Technical Bulletin

Volume 22, Issue 03, September 2015

New VersaPour 3.0 Diffuser

ICD - 85-2406C Sonic UDM Field Fix

New Patent Page on Lancer Website

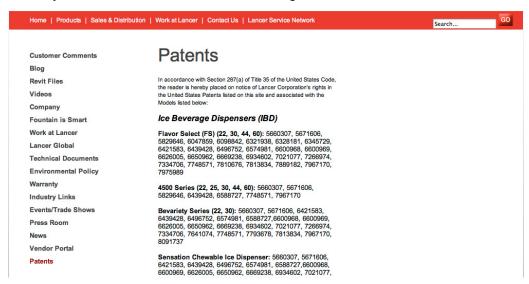
Due to new Patent law, Section 287(a) of Title 35 of the United States Code, Lancer is no longer required to post a units patent information dirently onto the unit. Instead a new Patent Page was created on our website: *lancercorp.com/pantents*.

This new web page houses all of our patent numbers in one simple and easily accessable location. Each patent number is organized by unit and model number. A url reference of the patent page is located on all of our units name plate labels and dispenser mobile pages to coicide with the new patent law.
